HISTORIC AND DESIGN REVIEW COMMISSION

HDRC CASE NO: 2019-553
COMMON NAME: 204 HAYS
ADDRESS: 728 CHESTNUT ST
LEGAL DESCRIPTION: NCB 535 BLK 23 LOT 1 EXC NW 15.68FT TRI
ZONING: D
CITY COUNCIL DIST.: 2
APPLICANT: Adam Gates/Adam Word Gates - Architect
OWNER: Stuart Allen/ALLEN STUART
TYPE OF WORK: Construction of three, 3-story residential structures
APPLICATION RECEIVED: September 13, 2019 (Postponed by Applicant)
CASE MANAGER: Edward Hall

REQUEST:

The applicant is requesting conceptual approval to construct three, 3-story residential structures at 204 Hays and 728 Chestnut. The proposed new construction will feature a total of five residential units. These lots are zoned Downtown only.

SITE PLAN
1" = 10'

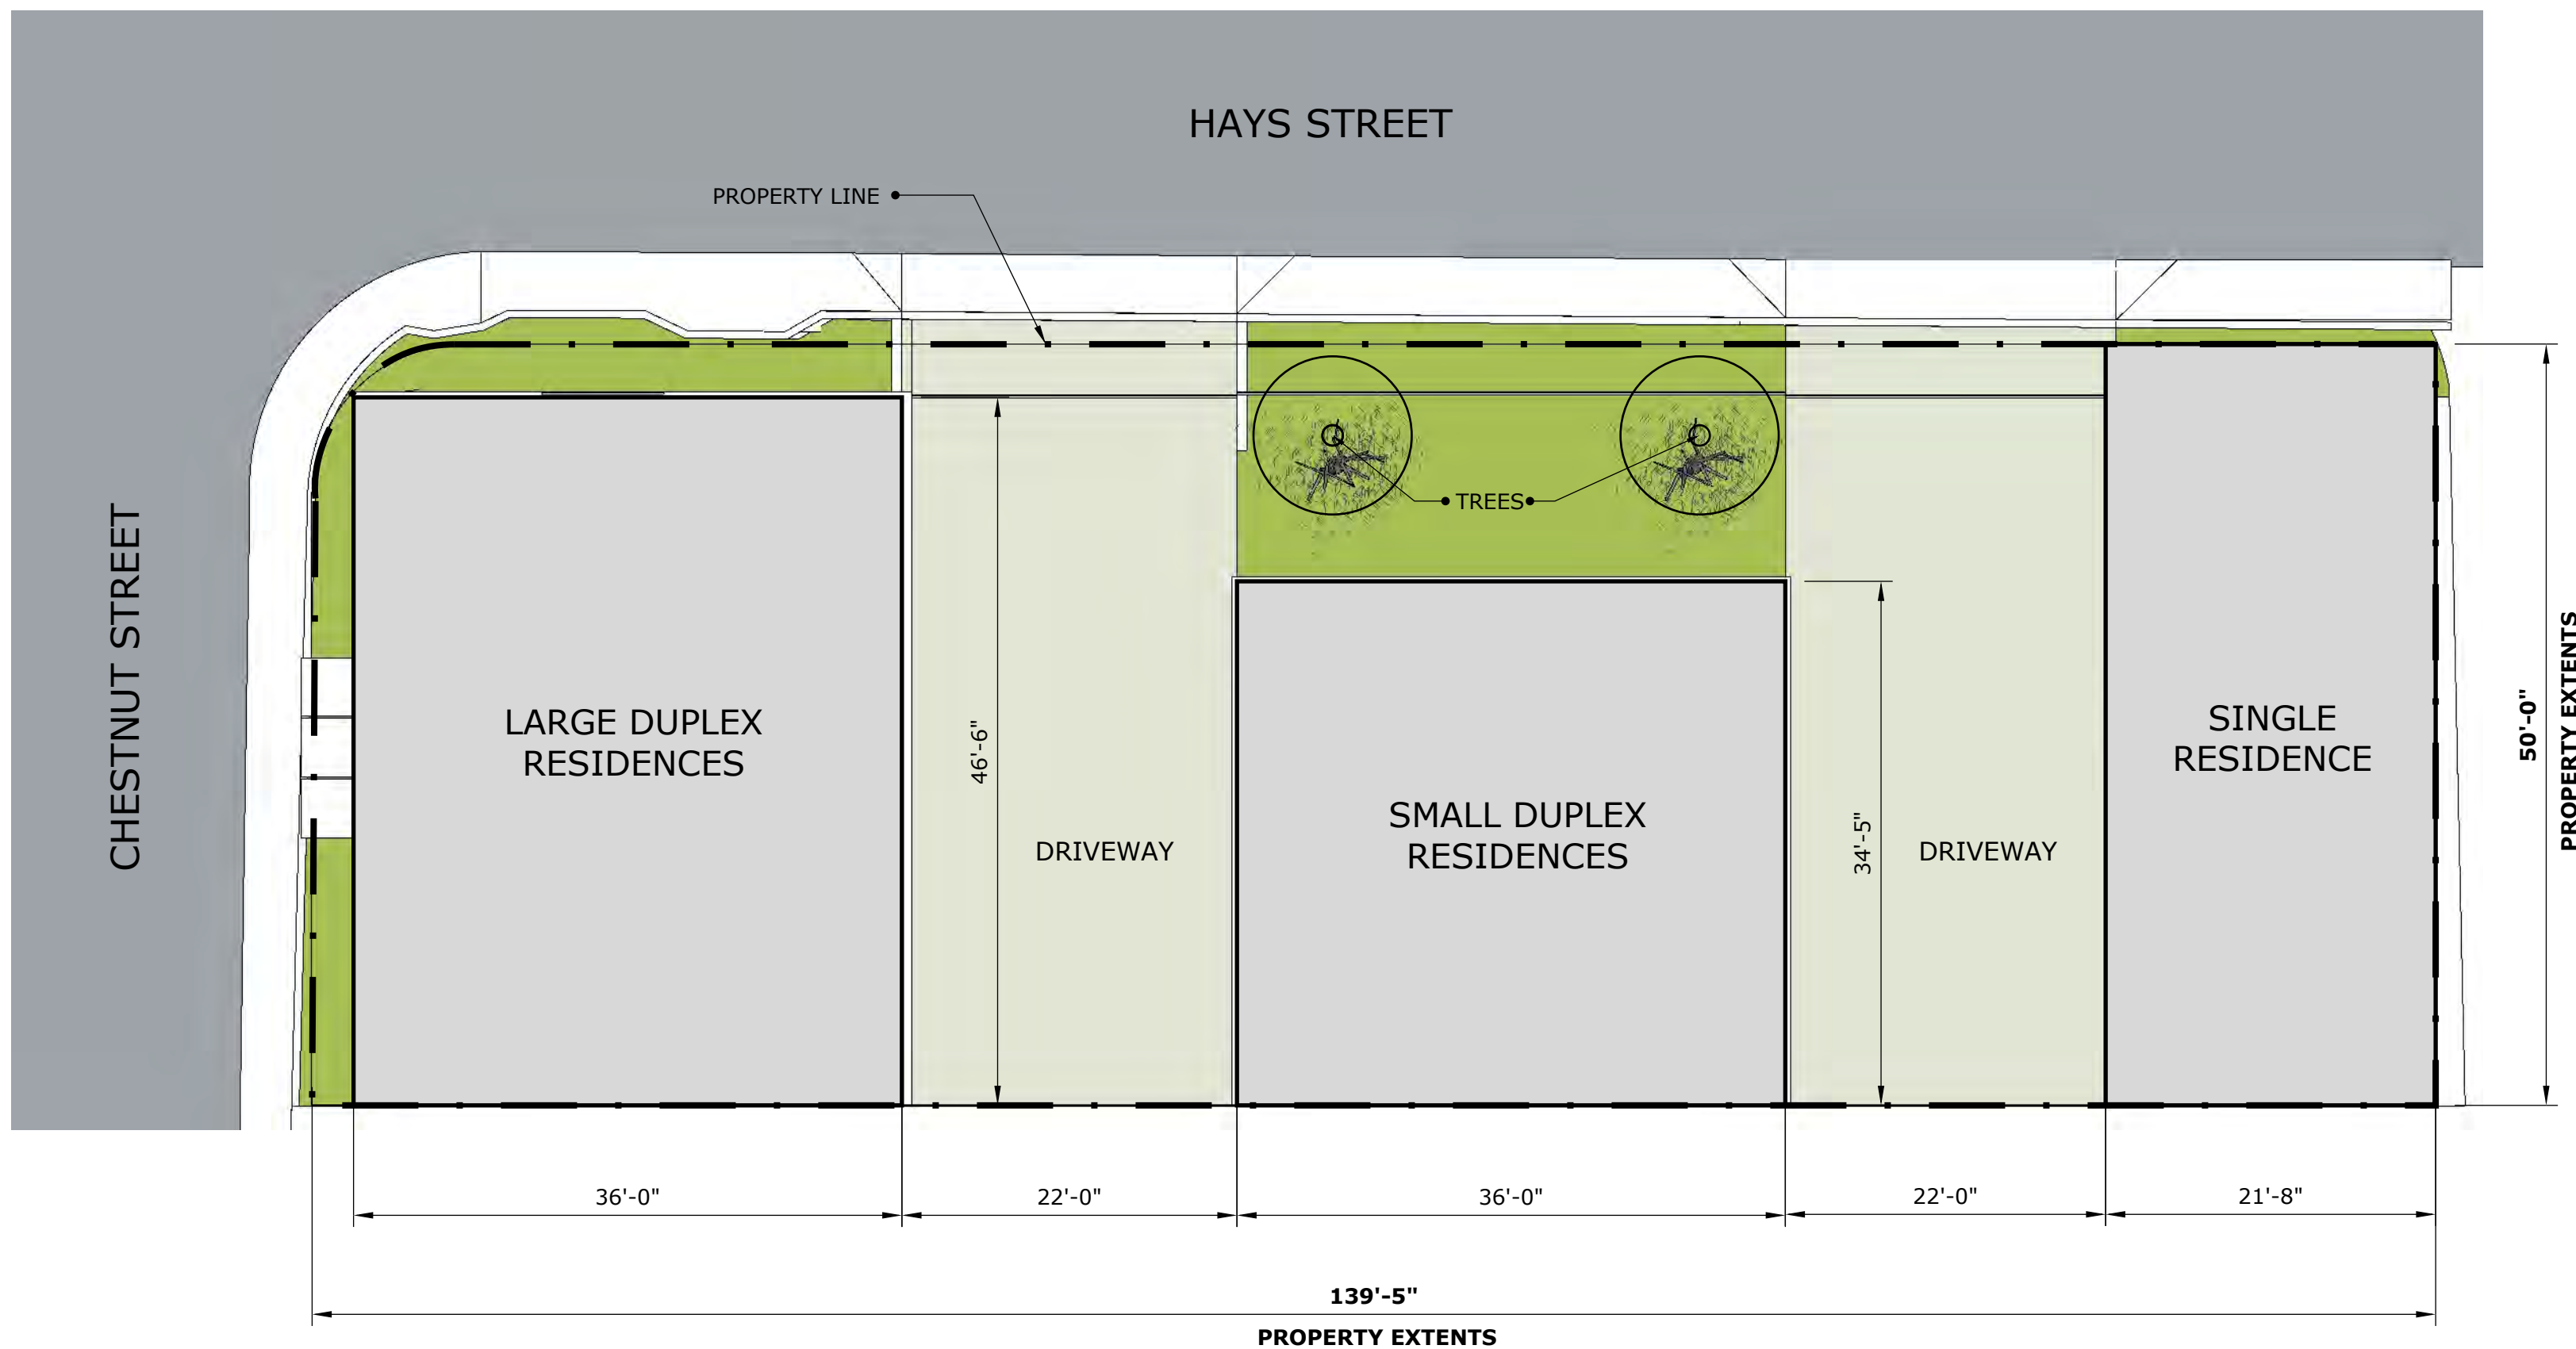
- e. **SIDEWALK & SETBACK WIDTH** – The Downtown Design Guide requires that a minimum of a seventy-two (72) inch sidewalk be provided, and that a continuous landscaped and hardscaped area should be provided adjacent to the curb on predominantly non-commercial streets. The applicant has provided the landscaped and hardscaped area. Staff finds that the applicant should match the existing sidewalks found on Hays and Chestnut.

- f. **LANDSCAPE & HARDSCAPE** – The applicant has noted the installation of a parkway along the curb, as noted in finding e and has noted in the installation of street trees, consistent with the Downtown Design Guide. Additionally, the applicant has provided detailed landscaping plan noting landscaping materials and their planned locations.

- g. **PARKING & ACCESS** – The Downtown Design Guide notes that parking should be integrated into the project that they serve. The Downtown Design Guide also notes that with the exception of the minimum ground-level frontage required to access parking and loading areas, no parking or loading should be visible on the ground floor of any building façade that faces a street. The applicant has proposed parking to be located on the ground floor of one unit, and between the proposed duplex structures. Generally, staff finds the location of the proposed parking to be appropriate as it is between structures, and will be screened from the right of way at Hays and Chestnut.

- i. That the applicant continue to explore ways to separate the façade as noted in finding i.
- ii. That if EIFS is used, that the panels are sized and textured to resemble stucco with expansion and control joints.
- iii. That all windows be metal, feature an installation depth of two (2) inches within walls, and feature dark frames.
- iv. That all mechanical equipment be screened from view from the public right of way.

FULL NORTH ELEVATION

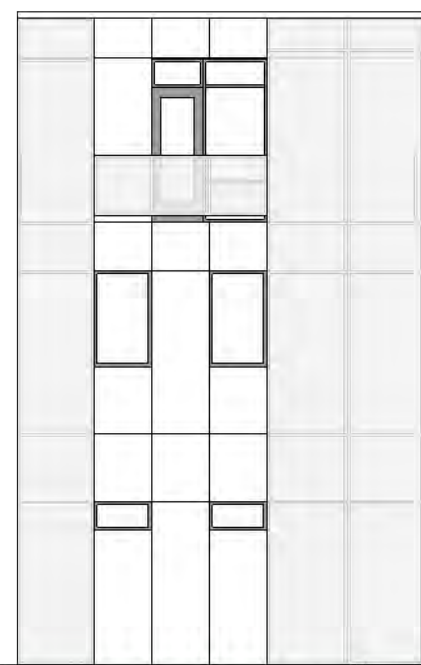
- i. **ARCHITECTURAL DETAILS** – The Downtown Design Guide requires for each structure to feature a base, midsection and cap. The applicant has separated the proposed new construction into three separate sections. The applicant has separated the base, mid-section, and cap with control joints and façade panel banding of varying heights, with the tallest being at the base, and the shortest at the cap. Additionally, the applicant has distinguished the building cap through the use of a parapet cap. Staff finds this to be appropriate; however, staff encourages the applicant continue studying ways to separate the façade.

COMMENTS/CONCERNS: AG: OVERVIEW OF LOCATION, EXISTING CONDITIONS,
AND PROJECT. JF: QUESTIONS REGARDING THE PROPOSED HEIGHT
IN RELATIONSHIP TO THE HAYS STREET BRIDGE, AL: DISCUSSION
REGARDING FENCING AT ROW, AL: RATHER THAN 3 SEPARATE
SETBACKS, CONSIDER A UNIFORM SETBACK, AL: APPLICATION OF
ART ON FACADES APPROPRIATE, AL: DISCUSSION REGARDING FACADE
TREATMENT, JF: CONSIDER YARD BETWEEN BUILDING + FENCE, JF: STUDY
CORNER AT CHESTNUT @ HAYS; REINFORCE DESIGN,
